Annex J

Coastal Access – Combe Martin to Marsland Mouth lengths 4 and 8, and VR11.

Representations with Natural England’s comments

August 2023

Figure 1. Map showing the Land Registry boundaries of [redacted] property (in red) together with the proposed route of the England Coast Path (in blue).

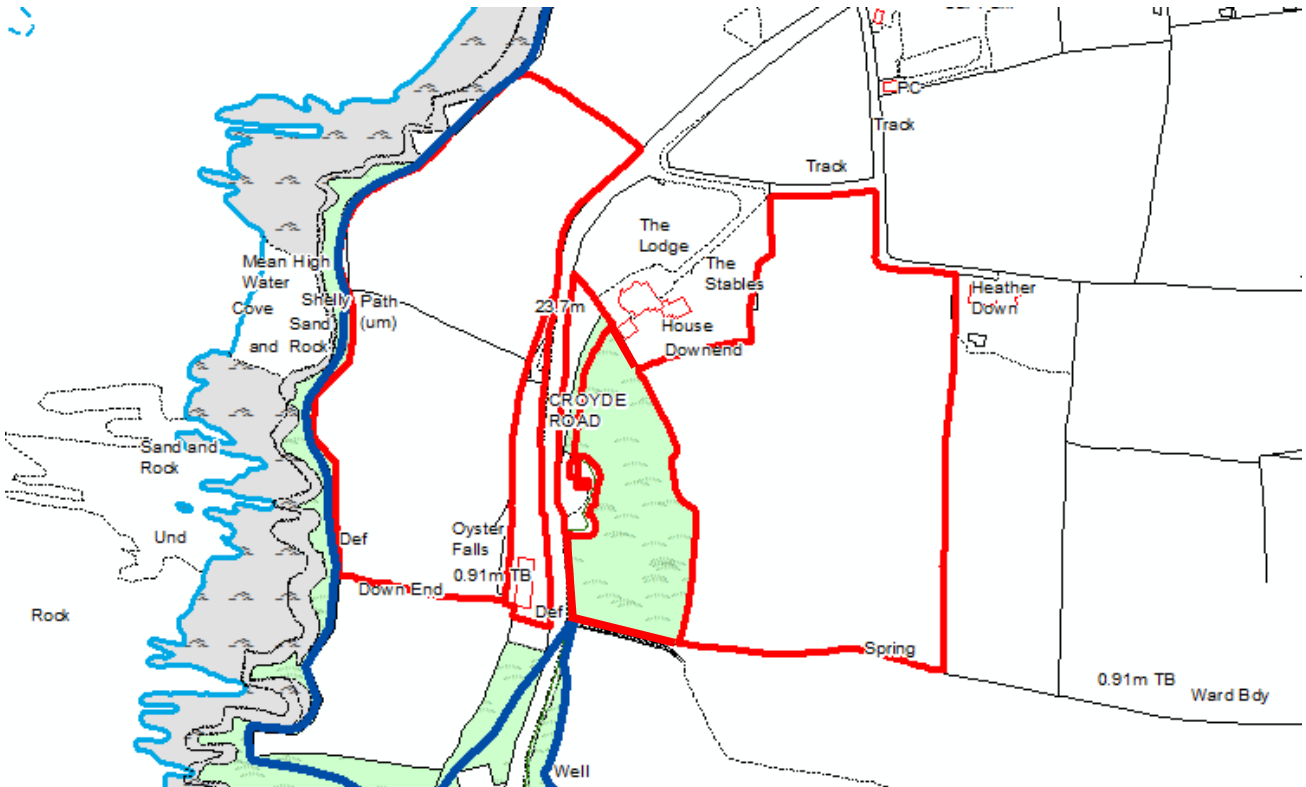
The indicative coastal access proposals sent to [redacted] prior to publication show an 'incursion' of coastal margin from Chesil Cliff House to Oyster Falls. This is 'not considered reasonable'. This land is currently enclosed by the path where it loops to the public road to gain access to steps leading up and down to the continuation of the path, but it abuts the road only, not the sea. It is not known whether this apparent anomaly has been corrected in the new proposals since the subsequent mapping is lacking detail.

Background

Figure 2. Extract from ArcMap showing the predicted MCERM Medium term (20-50 yr) SMP Policy retreat in metres for the 50 percentile © Environment Agency. [A = c.9m; B = c.7m]

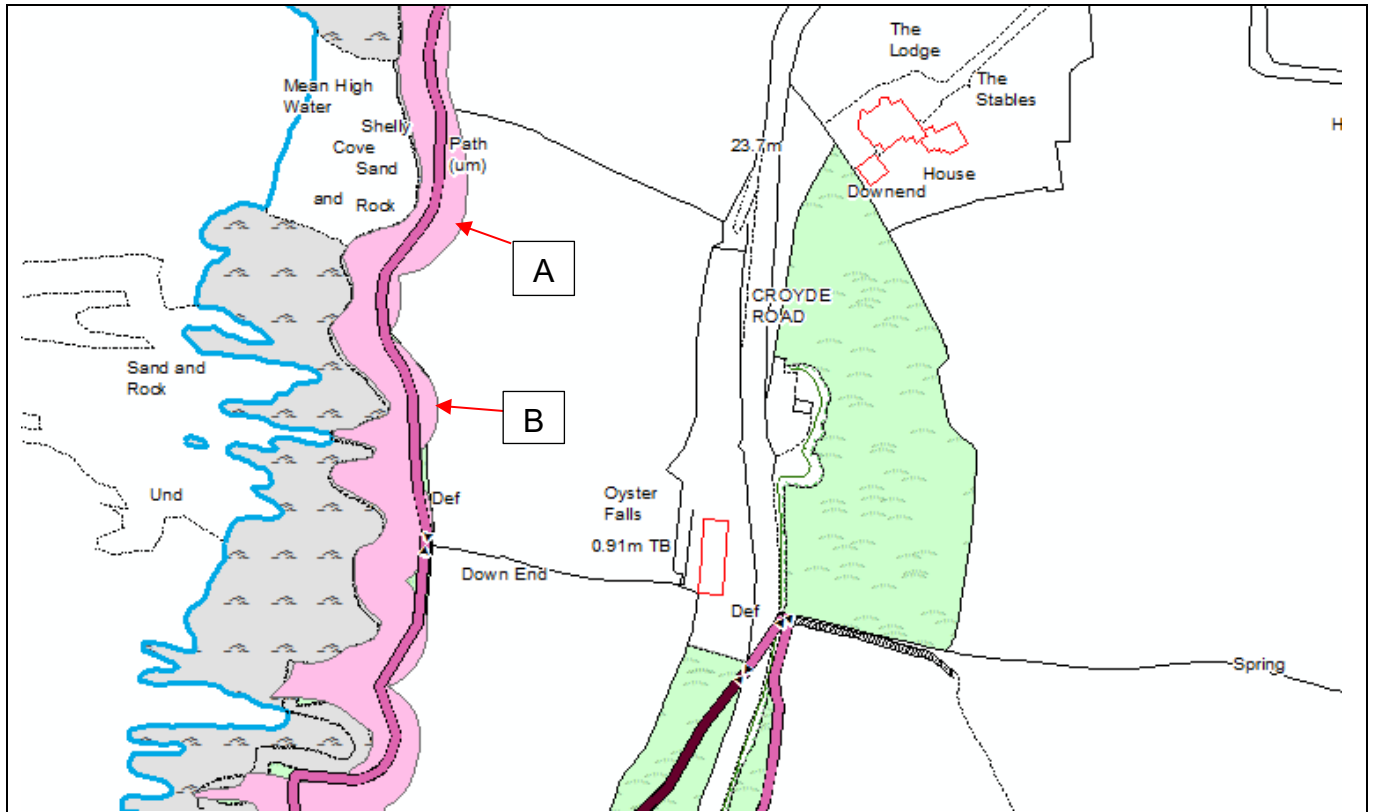
Information extracted from the Environment Agency MCERM Medium term (20-50 yr) SMP Policy retreat in metres for the 50 percentile, suggests that in the next 20-50 years, the coastline could retreat 7-9 metres in this location (see figure 2 below). This would still leave the path c. 75m from the house.

Figure 4. Annotated map and aerial photo showing existing SWCP and proposed ECP in relation to Oyster Falls. Yellow dashes – current SWCP. Dark red line – proposed ECP (route section CMM-4-S003).

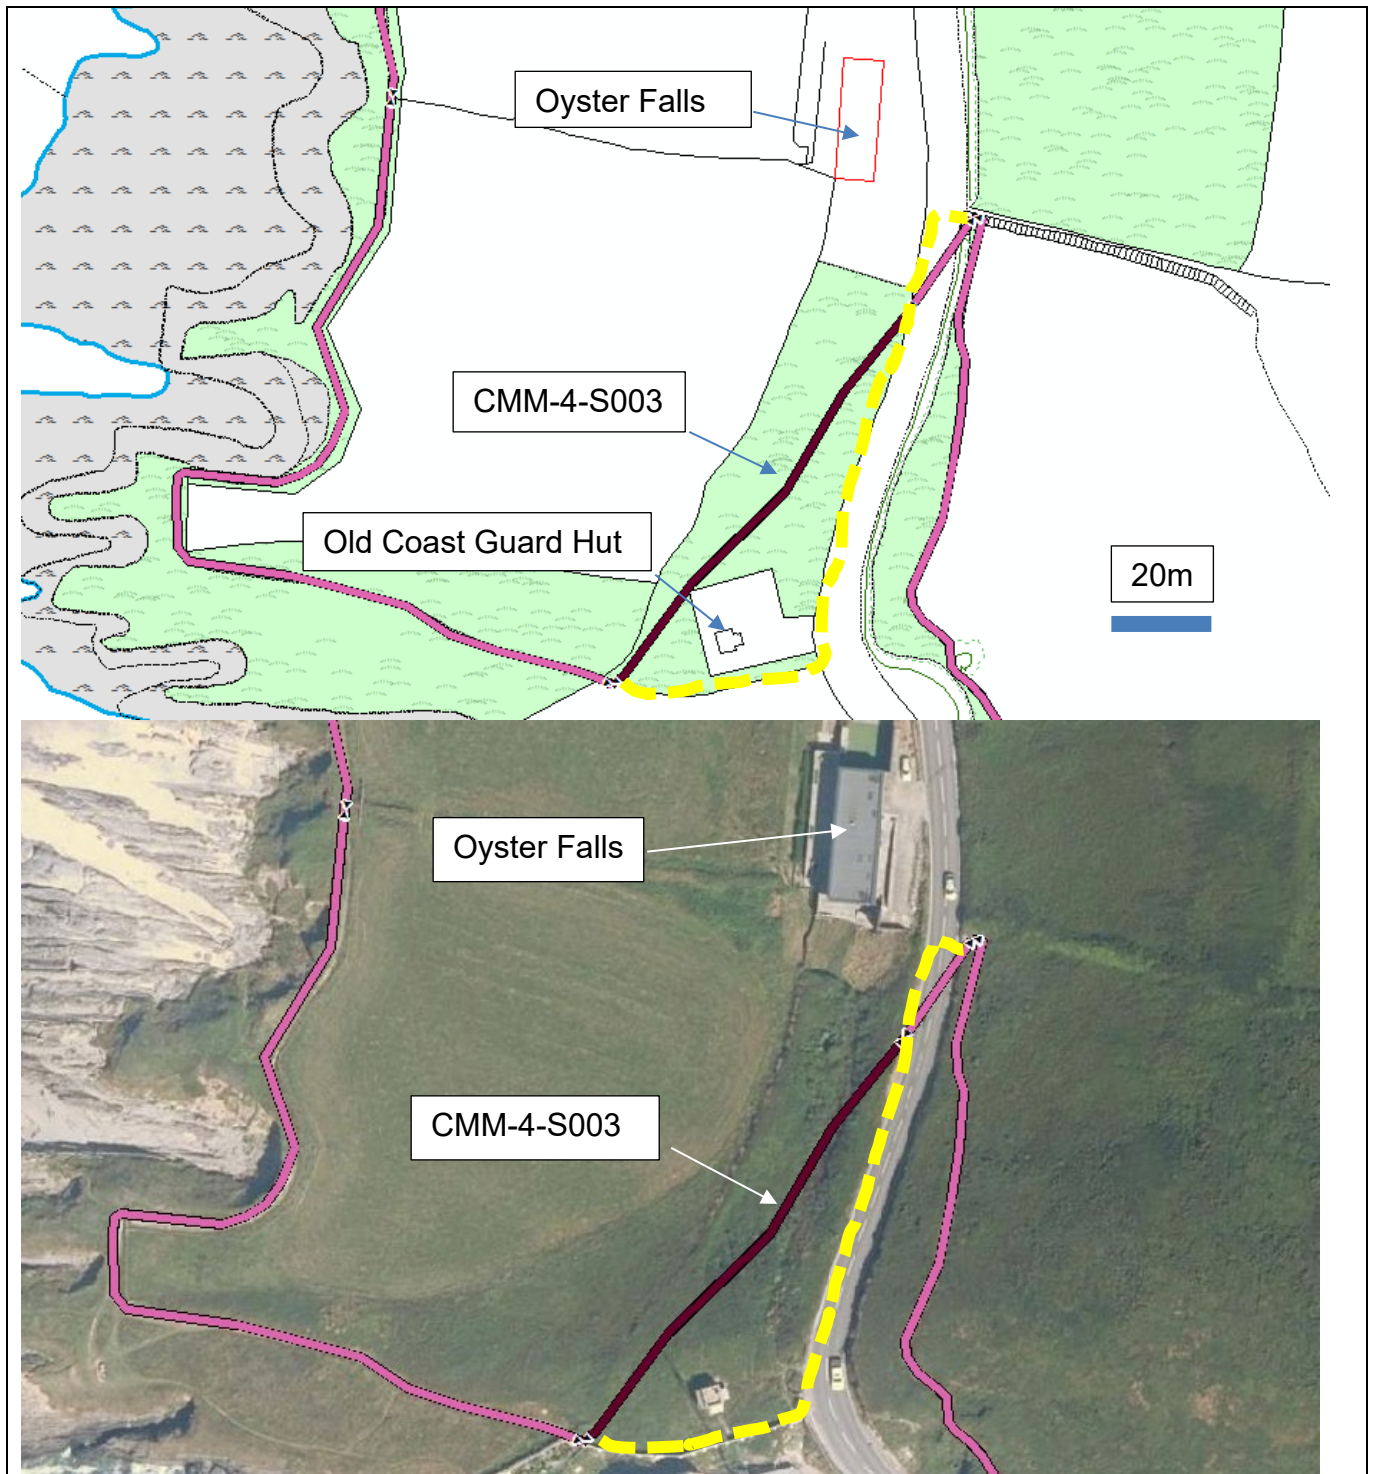
To avoid the intrusion of the proposal to realign the path (CMM-4-S003) Mr and Mrs Hare have suggested some alternatives:-

There is a low wall running alongside the road (the current route of the SWCP) between the former coastguard hut towards Oyster Falls. This wall could be removed and a roadside verge or pavement constructed from the top of the steps by the old coastguard hut to Oyster Falls. Additional road calming may be necessary (in addition to the existing red triangle pedestrians – no footway for 400 yds sign) – this could include rumble strips and 'Reduce speed' signs.

Various options were considered and the most practical (from an engineering point of view) was to follow route section CMM-4-S003 diagonally up the bank below the B3231 and reaching the road c. 25m from Oyster Falls, before crossing the road on a diagonal to the steps opposite Oyster Falls (shown as red dashes Fig.3. iii). See also Figures 4 and 5 below.

The proposed route would go diagonally up the bank to a small pedestrian refuge area (blue area in Fig.3.iii) at the side of the road. Screening could be provided to reduce the impact on Oyster Falls, however it is appreciated that it would not be possible to completely screen the proposed path from Oyster Falls. This is best seen in Figure 5) below which includes, as an insert, a photo provided by [redacted] in their representation.

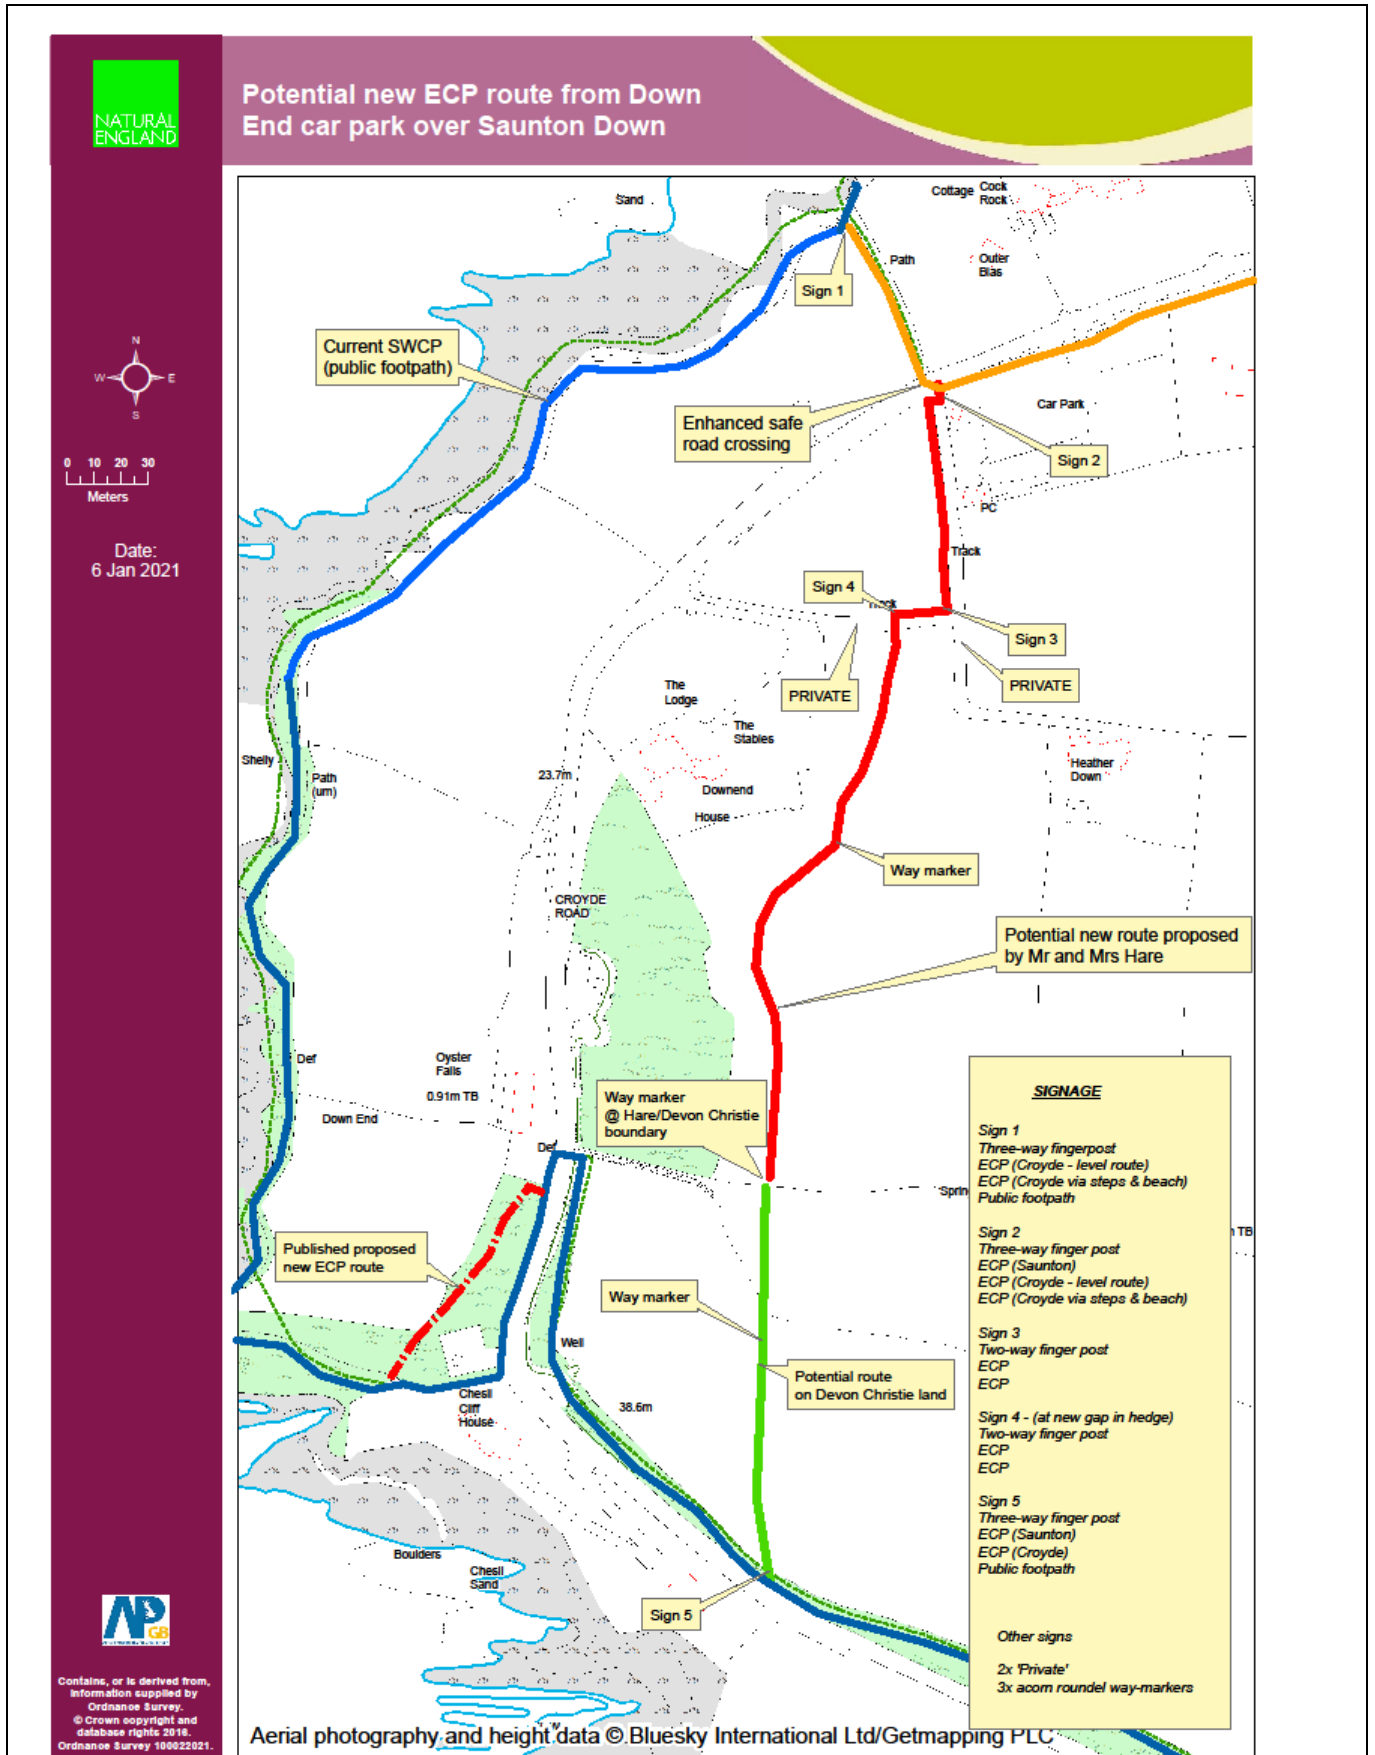
Option B. Avoid the problem – an additional route to connect with a better road crossing.

The new route which [redacted] would like to be a permissive path, would start at the top of the steps which leave the beach, cross Croyde Road by the Down End car park, go up the lane towards Heather Down House, up over the down on land owned by [redacted] before descending on land owned by [redacted] and re-joining the existing route at the top of the steps opposite Oyster Falls. This option has been offered to [redacted] and not rejected by them. This route (being high above the road and coast) would command wonderful sea views in both directions – down towards Saunton and Braunton Burrows and over Croyde Bay. This route would lessen any intrusion over the long-established properties at Oyster Falls and Chesil Cliff House. It would negate the need for any future changes to the 'official route' and would be in keeping with the existing route from Chesil Cliff House to Saunton which, being above the road, does not follow the immediate profile of the coast.

This option involves creating a new route from Down End car park, passing between Heatherdown and Down End House and going over Saunton Down before rejoining the existing route c 100 m to the east of Chesil Cliff House.

At a site meeting in September 2020 (between NE, the Hares and their agent and a representative from Devon Council Rights of Way), an ‘exploratory’ route was cut through the dense gorse scrub as far as the boundary between [redacted] land and that belonging to [redacted]. This route is shown as the solid red line in Fig 7 below. The views from this route are spectacular (the highest point of the route is c.80 m above sea level) – over Croyde Bay and baggy Point to the north and Braunton Burrows and the Taw/Torridge estuary to the south.

If the terms/conditions being discussed between [redacted] agent and [redacted] can be resolved, Natural England would support [redacted] proposal.
